20-016 Walthamstow Care Sites - Hurst Road
Design and Access Statement - Addendum v3
July 2023; updated August 2023; updated September 2023

This Addendum supercedes the relevant sheets of the submitted Design and Access Statement and summarises the amendments made through discussions with LBWF since January 2022.

5.1 Pedestrian Access, Refuse and Cycle Storage

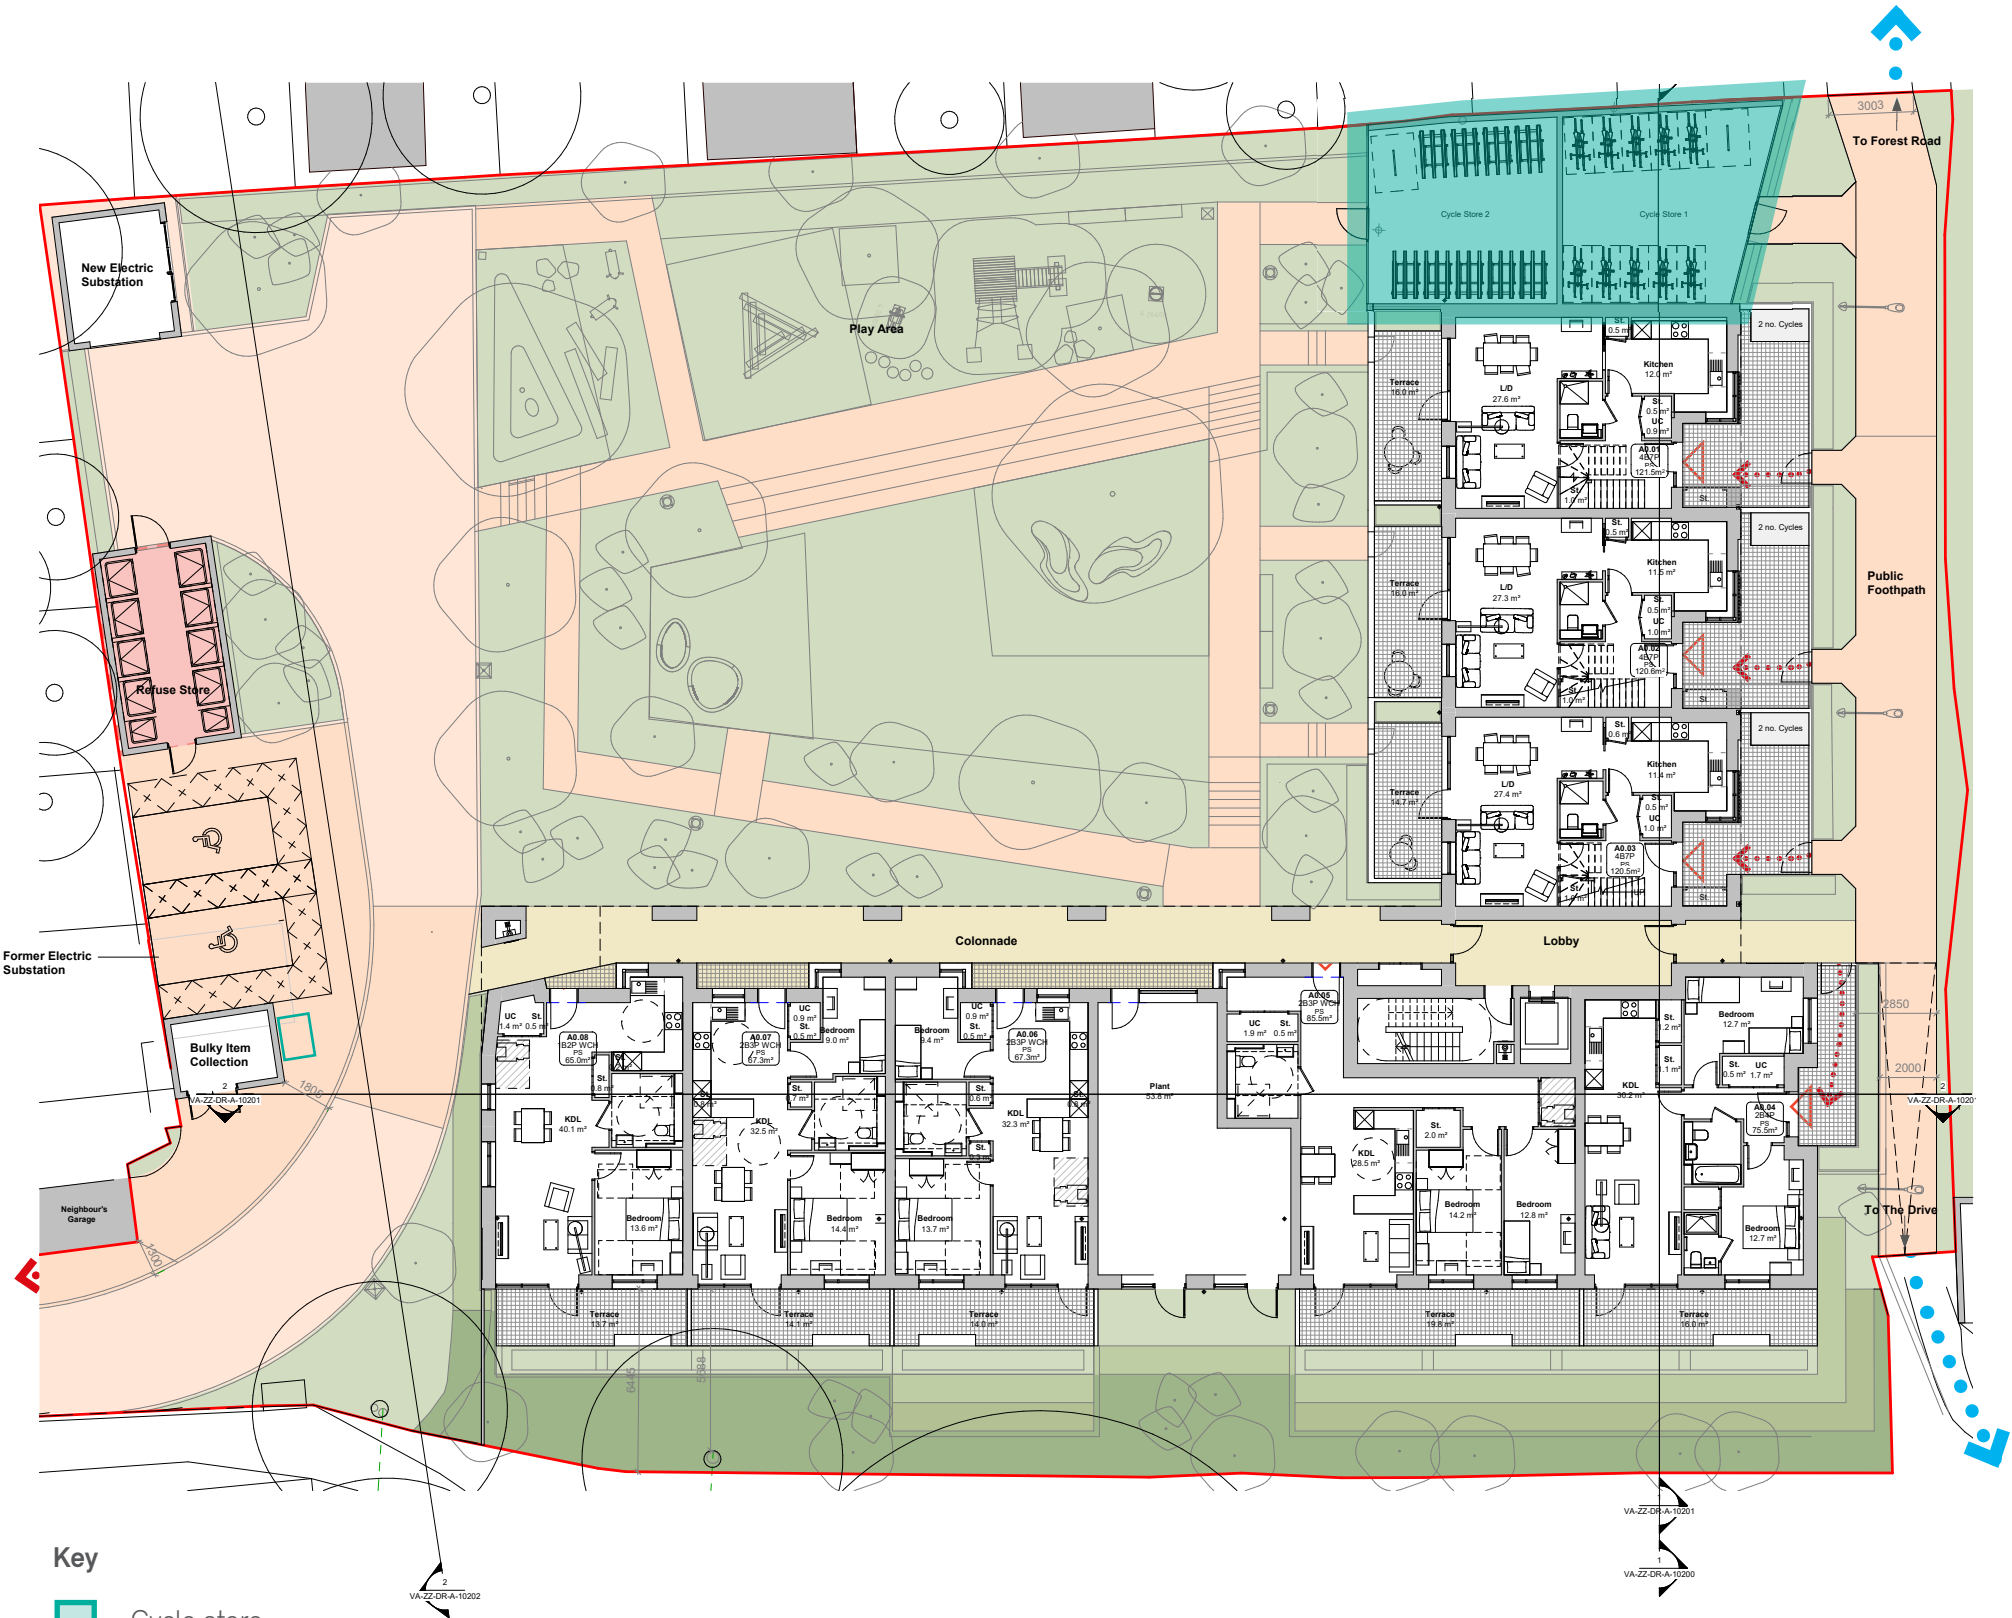
Update: The cycle store is divided into two parts - accessible via the eastern pedestrian footpath and accessible via the landscaped courtyard. The numbers of cycle spaces are as detailed below, as LBWF policy.

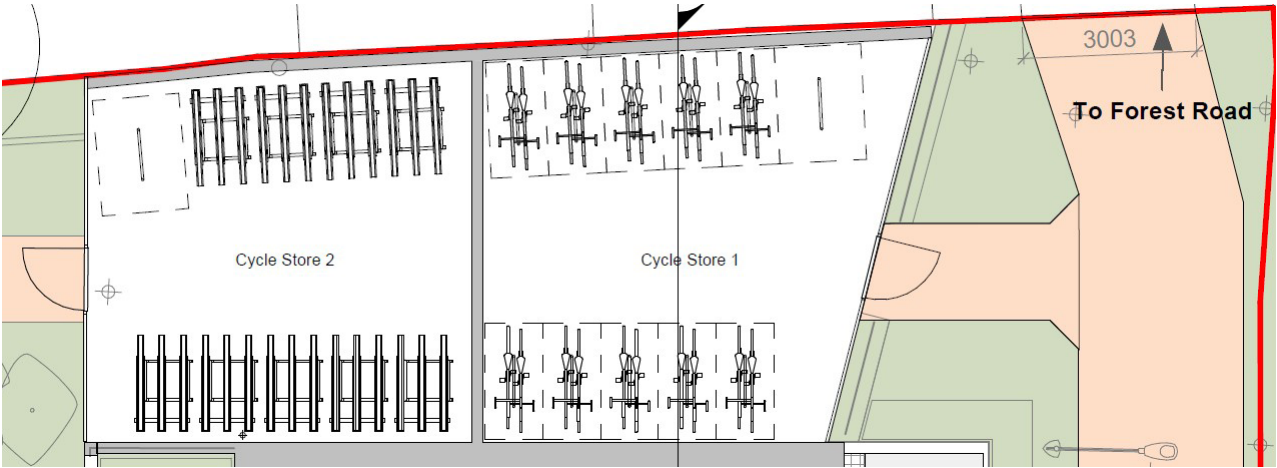
Update: The cycle store is divided into two parts - Cycle Store 1 - accessible via the eastern pedestrian footpath and Cycle Store 2 - accessible via the landscaped courtyard. The numbers of cycle spaces are as detailed below, as LBWF policy.

Update September 2023: LBWF planners and highways requested the internal layout as noted below and as setting out diagrams.

The right hand side cycle store 1 has 10 Sheffields hosting 20 cycle spaces, with a further 2 large spaces (Sheffield) = 22 spaces.

The left hand cycle store 2 is two tier trough cycle storage (Broxap or similar - Info Sheet below. Cycle Store 1 = 45 spaces (two tier) plus 2 large spaces (Sheffield).

There are 6 spaces in the proprietary cycle boxes for the maisonettes. A total of 75 spaces.

5.2 Vehicle access and parking - addendum

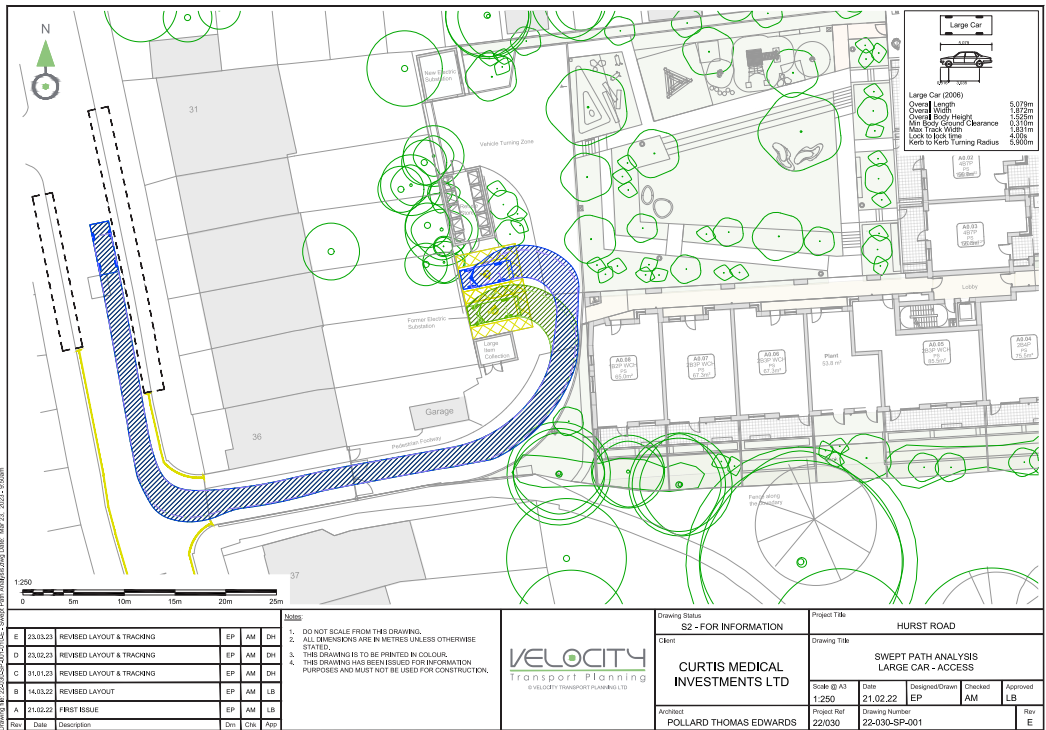
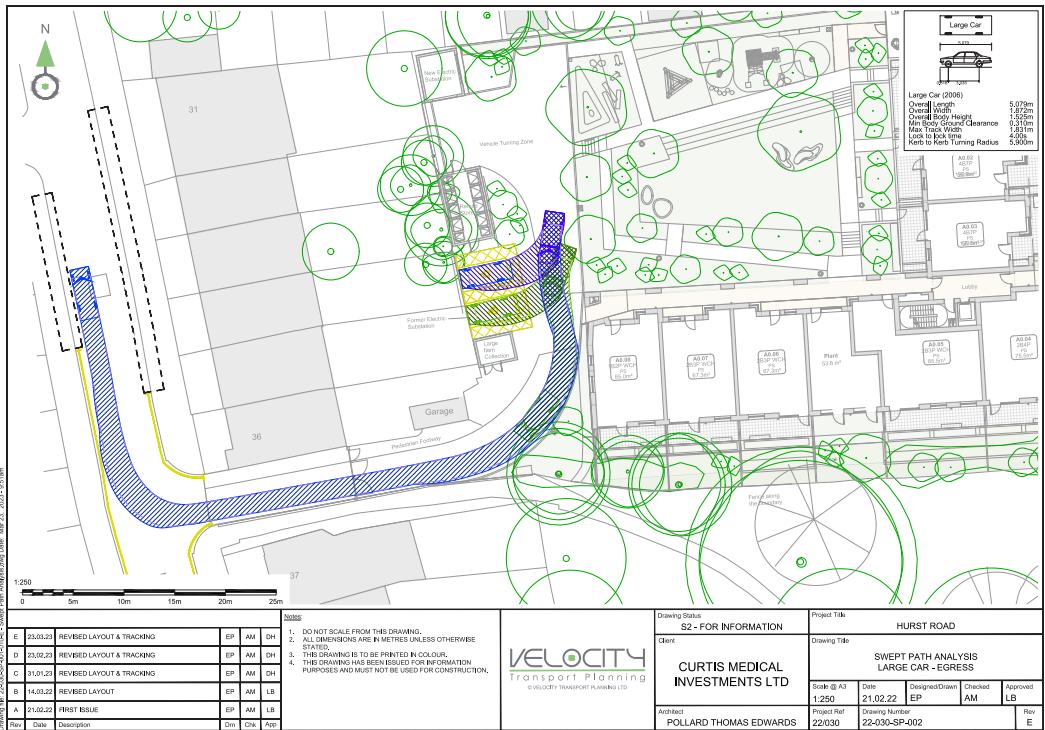
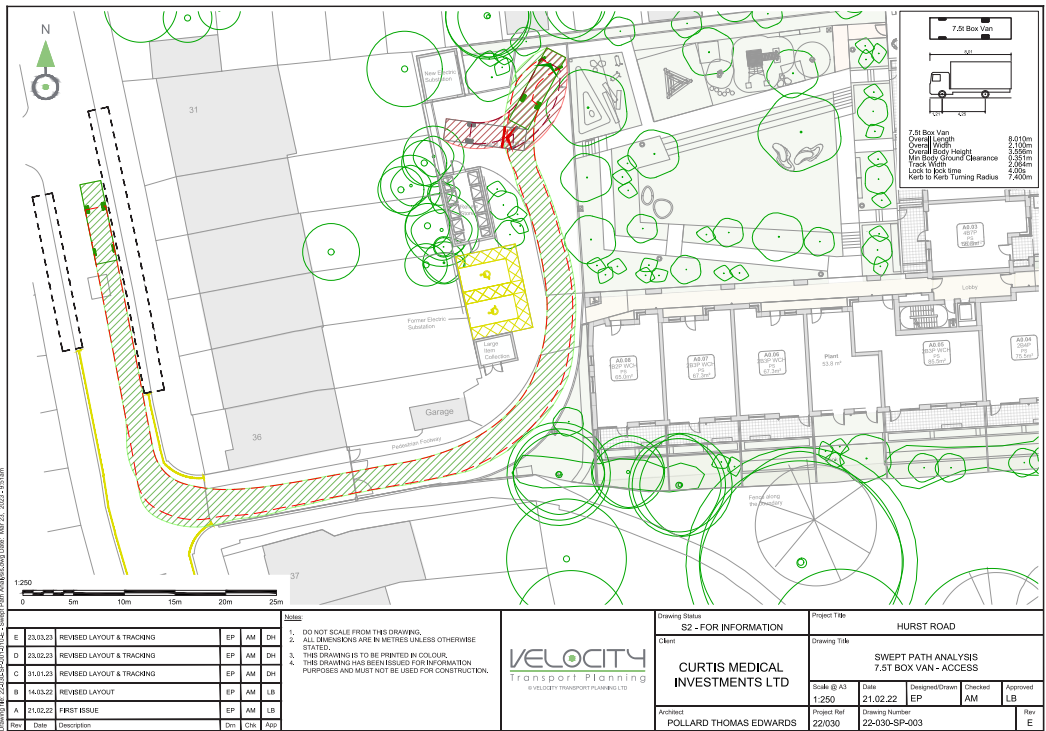
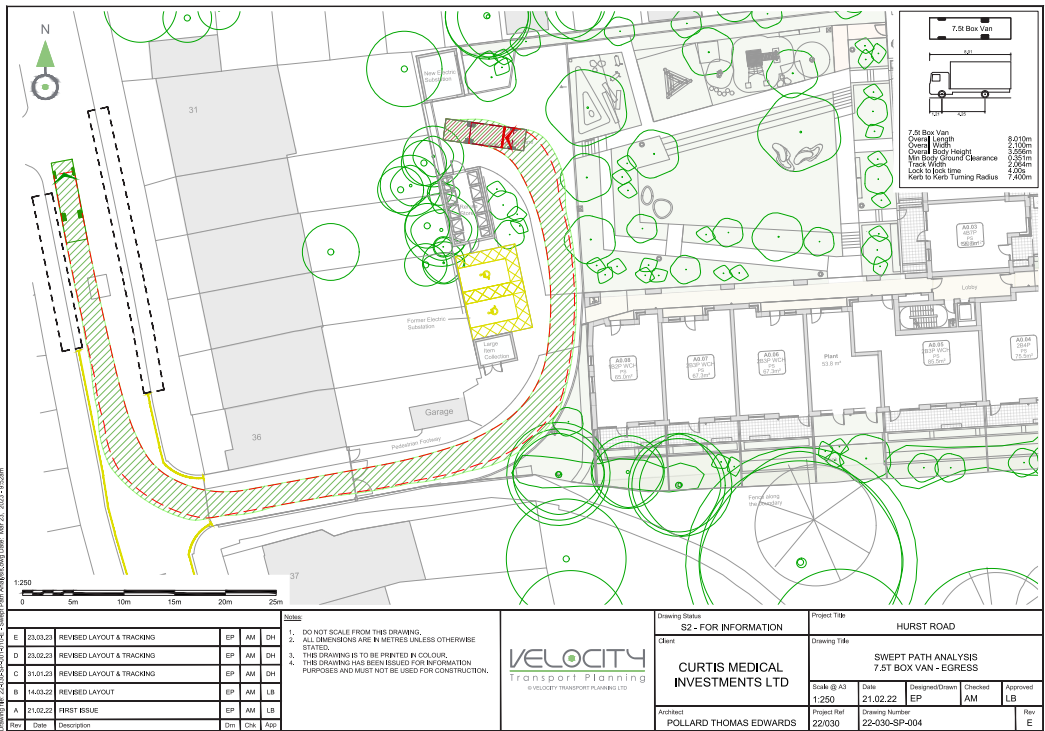
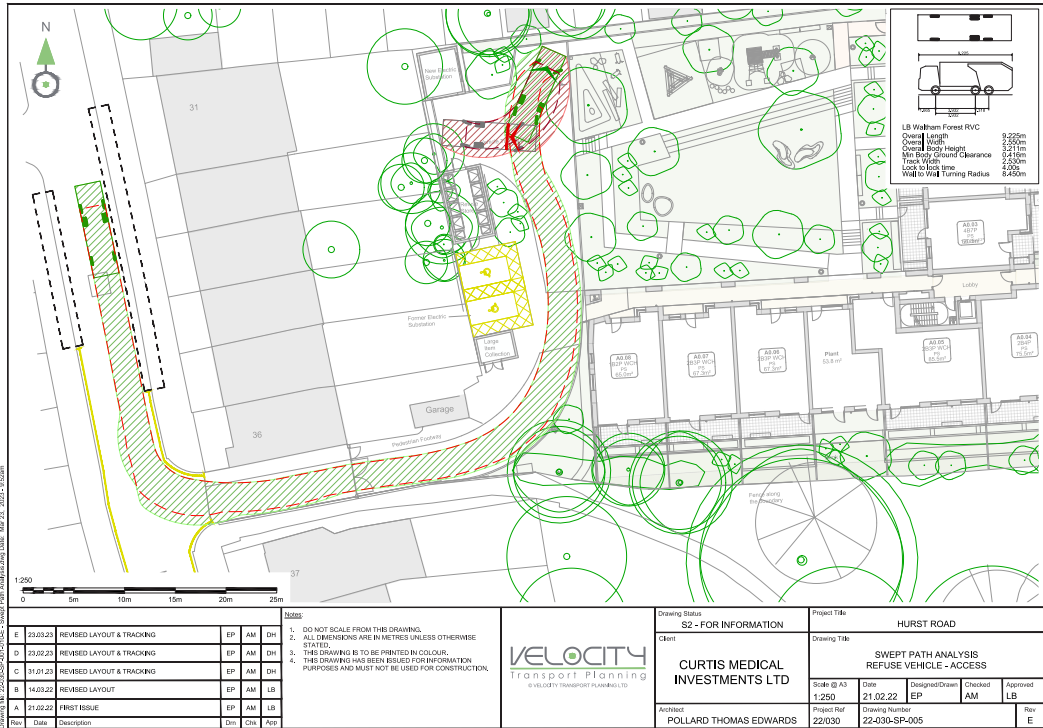
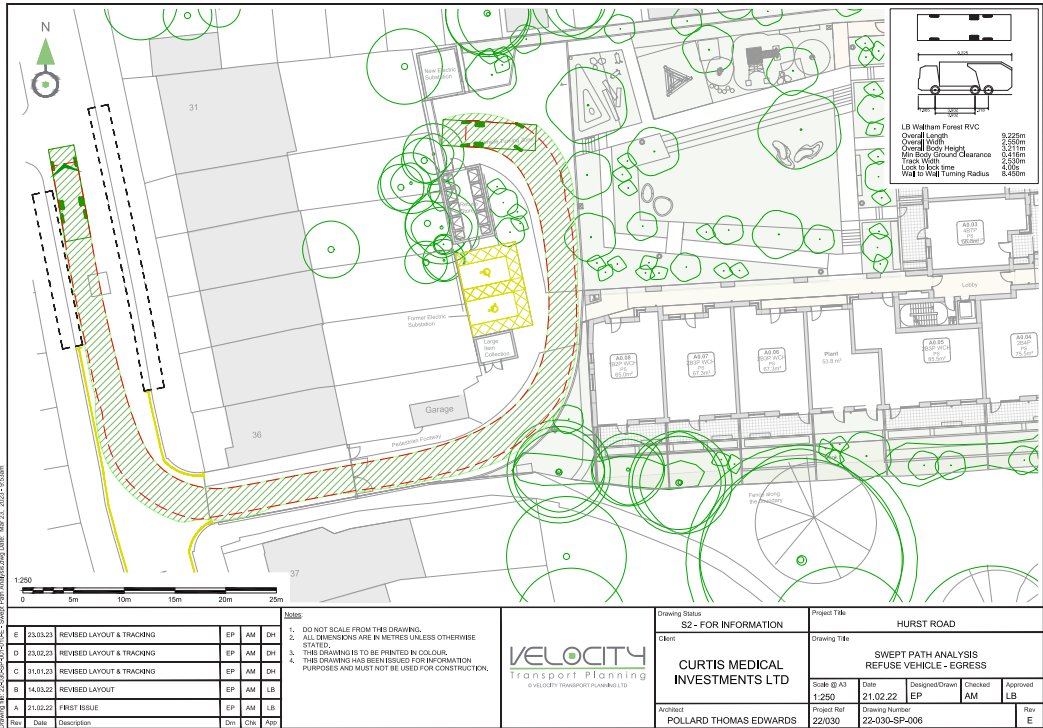
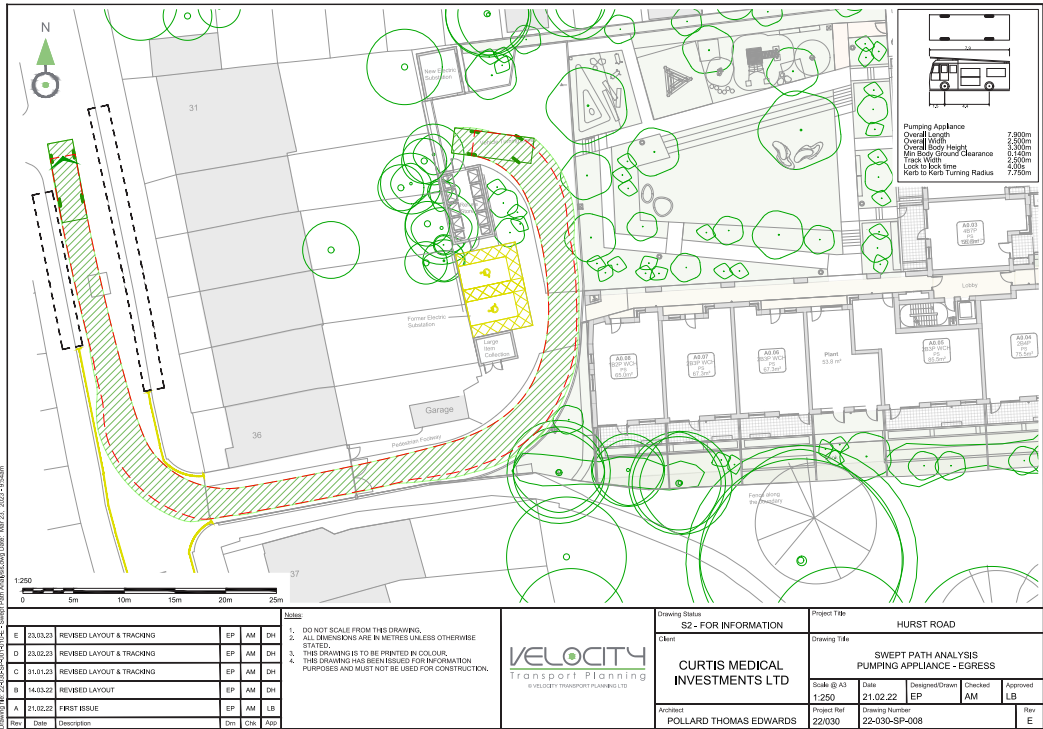
Update: The adjacent diagrams indicate the revised tracking, with the updated landscape layout, for:
